COMMANDANT NOTICE 10500

Subj : NEW DESIGN FOR AIDS TO NAVIGATION BUOY TOPMARKS

Encl: (1) Civil Engineering Drawing 121144, Revision D

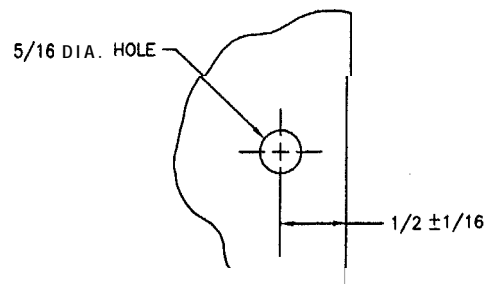
5. DISCUSSION.
 - a. The new **topmark** design consists of bi-planes made of plywood (see enclosure (1)). The plywood shall be either Medium Density Overlay (MDO) or High Density Overlay (HDO). **MDO** plywood is the type currently used for **ATON** dayboards, and is readily available at CG industrial facilities. It is an exterior-grade plywood with an impregnated-paper overlay that conceals the grain and provides a smooth surface for painting. **MDO** plywood comes with the overlay on one or both sides--either version is acceptable for this application. **HDO** is a higher quality (more expensive) plywood that typically has the overlay on both sides.

- c. The plywood bi-planes will **fit** on the existing **topmark** stands. However, they are thicker than the current foam design (1/2" vice 3/8"), so longer bolts will have to be used to mount them (use 1/4"-20 x 1-1/4" hex bolts, nuts, and washers).

D 9-03-01	W.D.	CHANGED MATERIAL AND THICKNESS OF ITEMS 1 AND 2.	K.V.
C 8-3-00	S.W.	CHANGED STOCK NUMBERS IN BILL OF MATERIALS.	S.A.
B 4-22-96	S.W.	CHANGED MATERIAL. DELETED ITEM 4 AND NOTE 2.	I S.A.
A 1-22-93	S.W.	MODIFIED STOCK NUMBERS IN BILL OF MATERIALS.	S.A.
REV.	DATE	APPR.	BY
DESIGNED: R.B.	U.S. COAST GUARD		HEADQUARTER:
DRAWN: S.M.	CIVIL ENGINEERING		
TRACED:	BI-PLANE TOPMARK DISK		
CHECKED:			
REVIEWED BY:			
S. McEvoy			
PROJECT ENGINEER			
REVIEWED BY:			
S. D. Walker			
C-ECV-38			
REVIEWED BY:	APPROVED:	DATE	
	R. J. Wells	6 JAN 91	
UNLESS OTHERWISE SPECIFIED:		DRAWING NUMBER	
AU DIMENSIONS ARE IN INCHES.		1 2 1 1 4 4	
TOLERANCES: DIM. ± 1/8		REV D	
SCALE: NONE		SHEET 1 OF 1
